HISTORIC AND DESIGN REVIEW COMMISSION

HDRC CASE NO: 2015-280
ADDRESS: 3903 N ST MARYS
ZONING: R6 HS RIO-1
CITY COUNCIL DIST.: 2
LANDMARK: Brackenridge Park
APPLICANT: Tim Morrow/San Antonio Zoological Society
OWNER: City of San Antonio Parks and Recreation Department
TYPE OF WORK: Giraffe exhibit, phase two
REQUEST:

SAN ANTONIO ZOO – GIRAFFE EXHIBIT (PACKAGE 2)

Elevated Deck Material: Trex composite decking

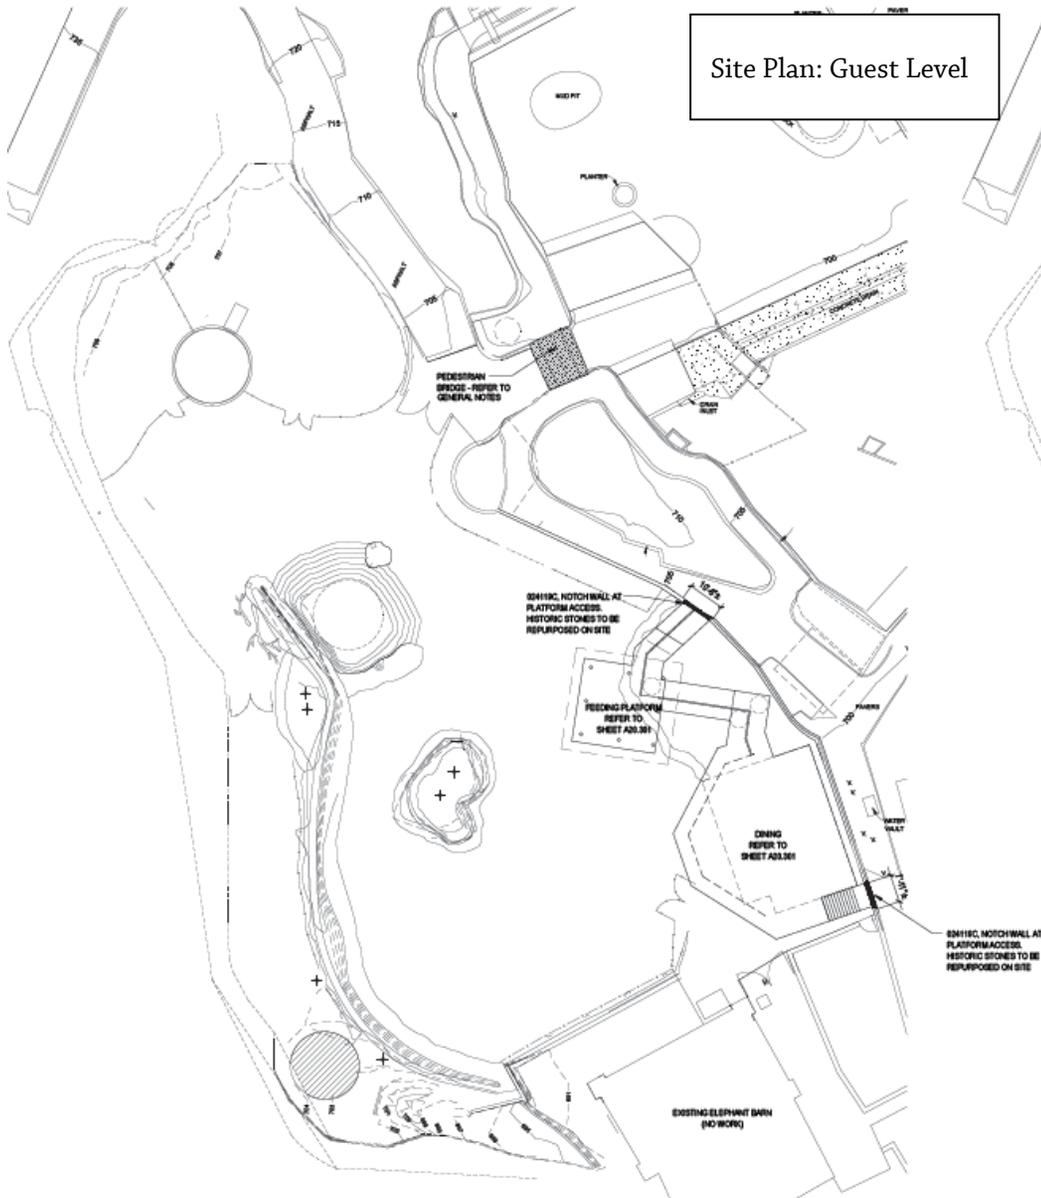
- b. The applicant has proposed to construct an uncovered, elevated dining deck as well as a new covered elevated platform that is to rise approximately 15 feet above the level of the existing pedestrian walkway and is to be constructed of heavy wood timber, dimensional lumber, Trex composite decking and a standing seam metal roof and include a hoofstock holding pen beneath. The proposed materials are the Guidelines for New Construction 3.A.i.

Roofing: Rusted Roofing’s corrugated metal roof with weathered rustic finish

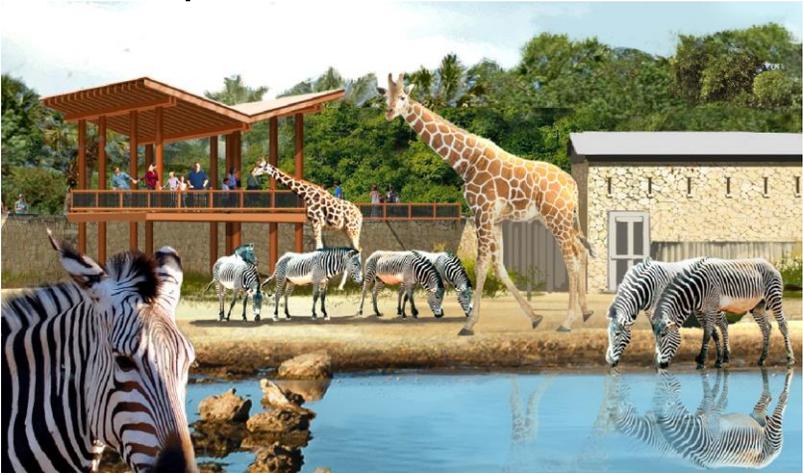
- d. The applicant has noted that the standing seam metal roof will have a weathered rustic finish. According to the Guidelines for Exterior Maintenance and Alterations, new or replacement roofs should have a galvalume finish as well as panels that are 18 to 21 inches in width, ensure that seams are an appropriate height (1 to 2 inches), use a crimped ridge seam that is consistent with the historic application and a low profile ridge cap .

1. That portions of the existing, historic wall that the applicant has proposed to remove are properly salvaged and stored by the San Antonio Zoo for future use with this particular wall.
2. That the proposed standing seam metal roof feature of the elevated feeding platform feature a galvalume finish.
3. That the proposed open air pedestrian bridge feature materials to match those of the proposed Realm Guardrails; stained wood long with black vinyl wire mesh.

Realm Guardrail: Stained wood logs with black vinyl wire mesh

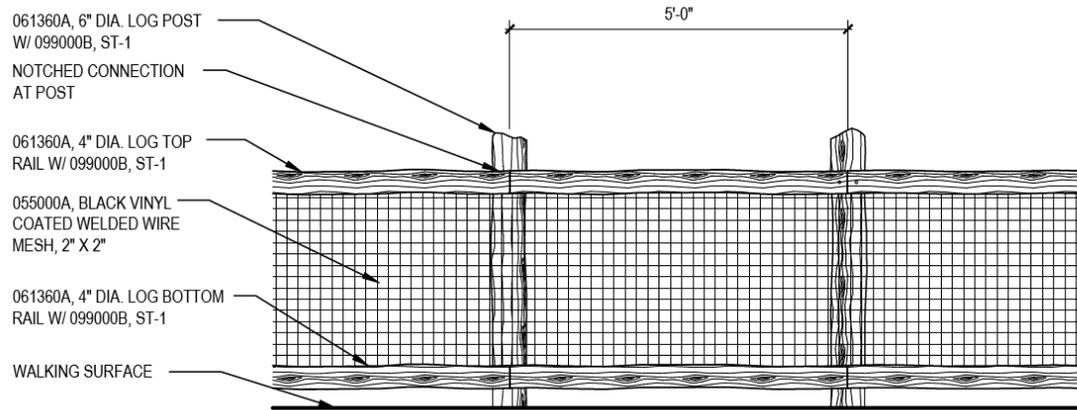
- e. According to the Secretary of the Interior's Standards for Rehabilitation numbers 9 and 10, new additions, exterior alterations or related new construction shall not destroy historic materials that characterize a property. The applicant has proposed to install guardrails composed of wood logs and black vinyl coated welded wire mesh. This proposal is appropriate provided that the proposed guardrails do not damage the historic stone walls.

- f. The applicant has proposed an open air pedestrian bridge with realm theme guardrail to replace the existing pedestrian bridge. Staff recommends that the applicant match the materials of the proposed Realm Guardrails, stained wood logs with black vinyl wire mesh.
